Brent Decommissioning Derogation: An evaluation

**The Ministry of Infrastructure and Water Management
Government of The Netherlands**

an independent evaluation group

4 October 2019

Page 22: Figure 7 shows the general arrangement of drawdown system and the piping system that goes into the cells (see also Figure 10).

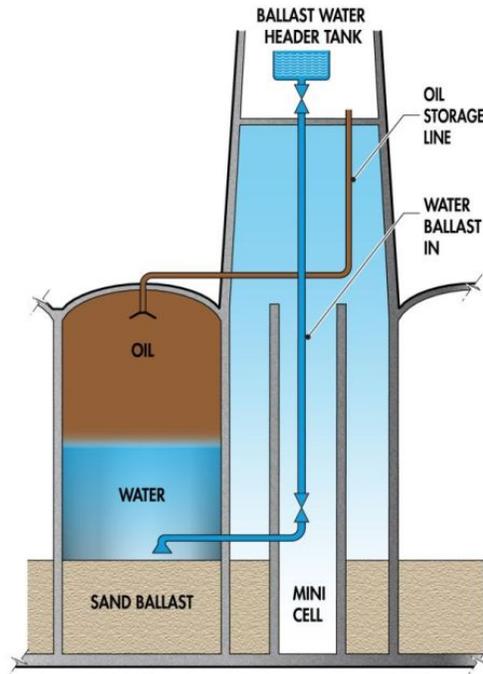
Page 88: From the report by Aker Kvaerner that studies the existing pipework of the GBS cells, it is found that:

- *“The pipework is in place and accessible via the utility leg”*
- *“There are existing operational procedures and experiences for working down the utility leg”* that can *“reduce the amount of subsea activities required”*.
- The disadvantages are the risk of H₂S poisoning if personnel work down the utility leg, equipment cannot be deployed via the pipelines, the topside needs to be in place to break into the pipework from a lower level.
- *“The existing pipework could be used to pump fluids to and from the storage cells”*

Page 91: Drilling a large hole into the cell top is technically challenging and associated with major safety risks.

- *“The existing pipework is in a poor or unknown condition. It cannot be used as it is to support remediation activities. Modification and reinstatement would be required to make it suitable for use”*. This statement is in direct contradiction with several other statements about the possibility of using the piping system for pumping fluids. Also, these modifications were never considered as an option.

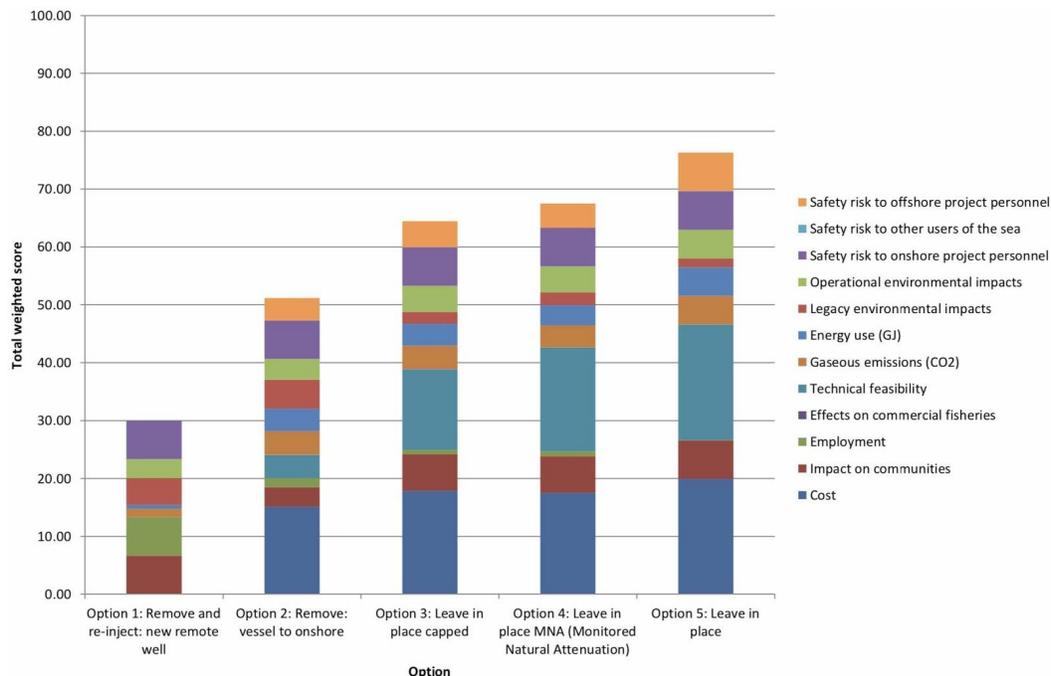
“On the basis of this assessment, the ‘CA-recommended option’ for the Brent Delta cell contents is Option 5 ‘Leave in Place’.”

“In all six of the scenarios, the order of the five options does not change as a result of the changes in weighting. Option 5 ‘Leave in place’ always has a higher total weighted score than the next best option”
